Official Transcript of Proceedings
NUCLEAR REGULATORY COMMISSION

Title: Advisory Committee on Reactor Safeguards
 Thermal Hydraulic Phenomena and
 Reliability and PRA Subcommittees

Date: Tuesday, April 18, 2017

The purpose of today's meeting is to continue our discussions on the South Texas Project's Risk-Informed Approach to Resolve GSI-191 that was held in our joint subcommittee meeting on April 5th, two weeks ago. The subcommittee will gather information, analyze relevant issues and facts, and formulate proposed positions and actions as appropriate for consideration by the full committee.

Figure 1. A graphical representation of the categories ($TW_{Cat(D_i^{small})}$) in STP Class 1 pipes showing the categories above the smallest $D_i^{small} = 9.34''$ (Supplement 3).

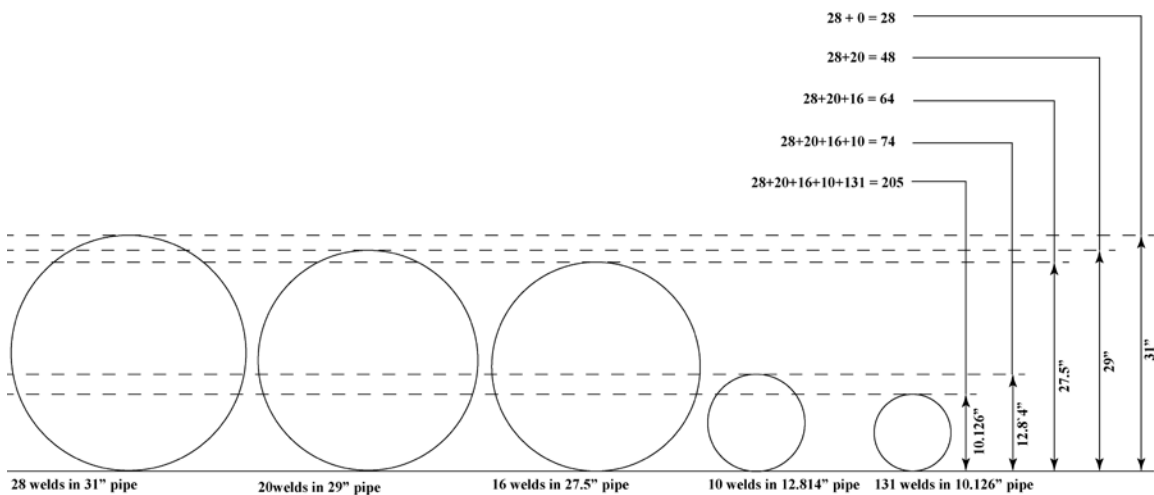
Question #2:

that involve discrete pipe sizes. The change in D_i^{small} from Supplement 2 to Supplement 3 brought in a different pipe size (weld category.) A detailed inspection of intermediate results is provided in the following.

Because pipe sizes are built in discontinuous diameters, the potential for a break at any size will inherently reflect this discontinuity. Figure 1 is an illustration of how the $Cat(D_i^{small})$ are formulated for the extent of break sizes relevant to the Case 2 results.
